# UNITED STATES PATENT AND TRADEMARK OFFICE

APPLICATION NO.	FILING DATE	FIRST NAMED INVENTOR	ATTORNEY DOCKET NO.	CONFIRMATION NO.
10/725,623	12/01/2003	Michael M. Kamrava	5603P001X2	4992
8791 7590 11/24/2009 BLAKELY SOKOLOFF TAYLOR & ZAFMAN LLP 1279 OAKMEAD PARKWAY SUNNYVALE, CA 94085-4040				
EXAMINER NGUYEN, CAMTU TRAN				
ART UNIT		PAPER NUMBER		
3772				
MAIL DATE		DELIVERY MODE		
11/24/2009		PAPER

### Office Action Summary

## DETAILED ACTION

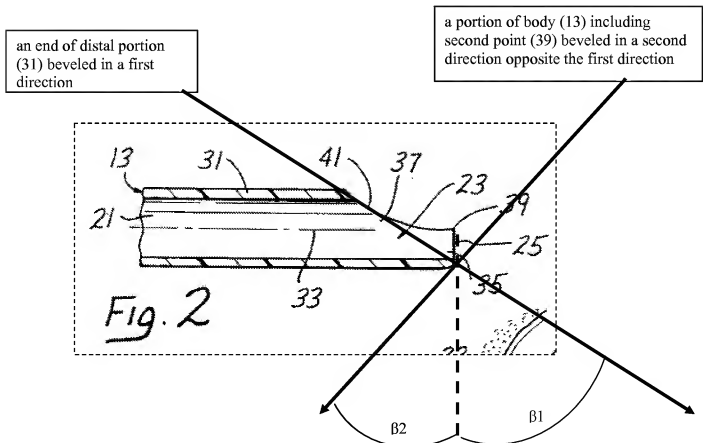
Bacich discloses a transfer catheter body (13) comprising a proximal portion (27), a distal portion (31), an elongated passage (21), the distal portion (31) having an end that is beveled in a first direction across the passage (21) from one side to another, thereby, rendering the bevel in its direction across the opening, as recited, a portion of catheter (13) including a second point beveled in a second direction opposite the first direction defining a tip, showing by  $\beta 1$  &  $\beta 2$  below. See illustration below.

In view of Bacich, it would have been obvious to one skilled in the art during the time of this invention to modify the Gobby's distal passage portion of the delivery section (51) such that it would have a bevel, as such would facilitate the delivery process.

With regards to claim 28 & 32, the second point on the catheter body (13) beveling on the second direction (see illustration above) yields a refined edge, thus, serving as a cutting tool.
